DEVELOPMENT PERMIT STAFF COMMITTEE RECOMMENDATIONS

The following is a list of conditions that must be met prior to issuance of the Development Permit.

Figure 1 – Explanatory plan indicating the requirements of Condition A.2.1 a, b, and c.

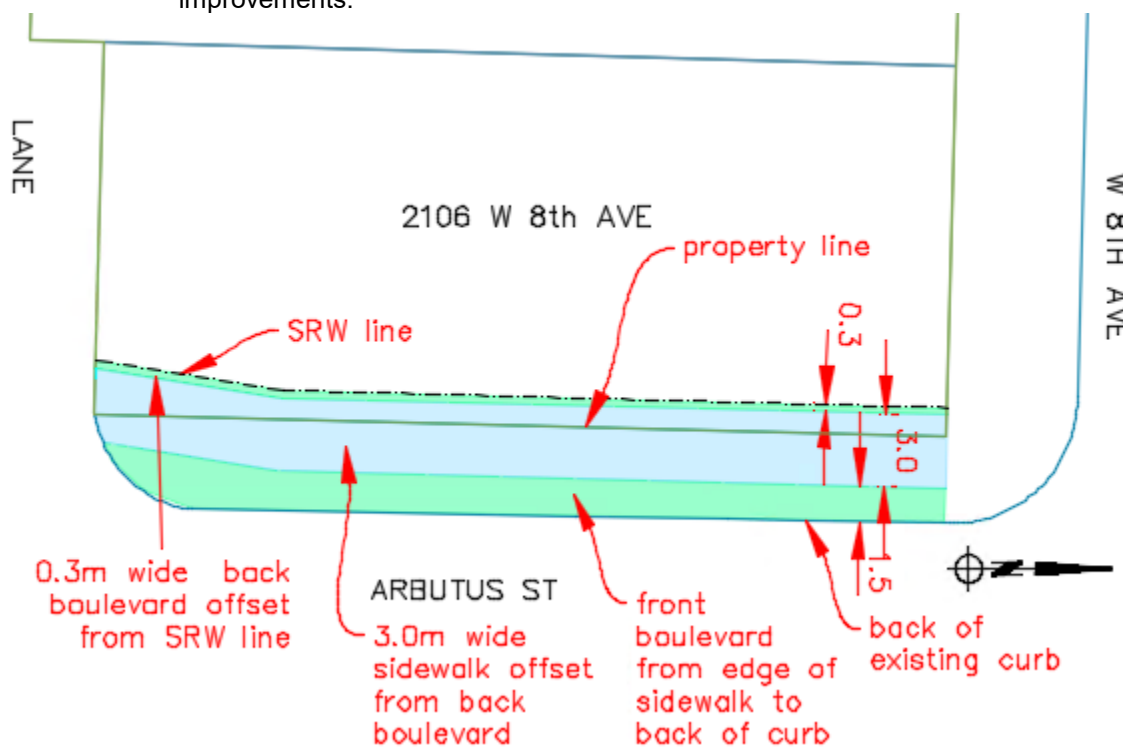
- i. Street improvements along Arbutus Street adjacent to the site and appropriate transitions including the following. These dimensions are provided as offset distances from the ultimate edge of the SRW area:

- a. 0.3m wide sod grass back boulevard;
 - b. 3.0m wide broom finish saw-cut concrete sidewalk;
 - c. Front boulevard in the remaining space between the edge of the sidewalk and the back of the curb;
